Exhibit A

Recommended Amendments to the 2018 International Building Code City of Amarillo, Texas

FIGURE 1511.3.1.1 HAIL EXPOSURE MAP

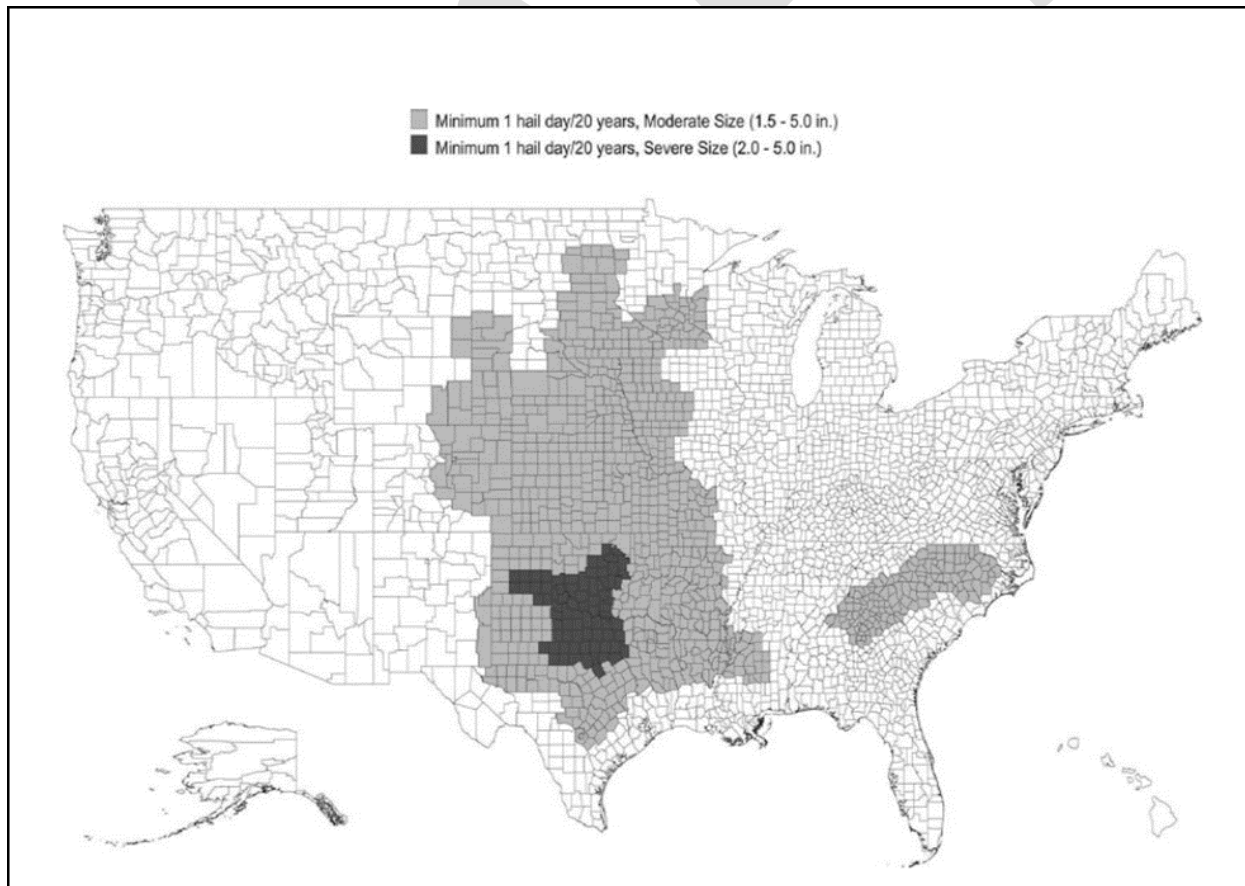
****Section 1511.3.1.1; insert Figure 1511.3.1.1; change to read as follows:**

1511.3.1.1 Exceptions. A roof recover shall not be permitted where any of the following conditions occur:

1. Where the existing roof or roof covering is water-soaked or has deteriorated to the point that the existing roof or roof covering is not adequate as a base for additional roofing.
2. Where the existing roof covering is wood shake, slate, clay, cement or asbestos-cement tile.
3. Where the existing roof has two or more applications of any type of roof covering.
4. For asphalt shingles, when the building is located in an area subject to moderate or severe hail exposure according to Figure 1511.3.1.1.

(Reason: Due to the of weather in the Panhandle, wind and hail damage is more prone when asphalt shingles used for re-covering; contractors unable to verify if any of the decking may need to be replaced and unable to verify the flashing integrity)
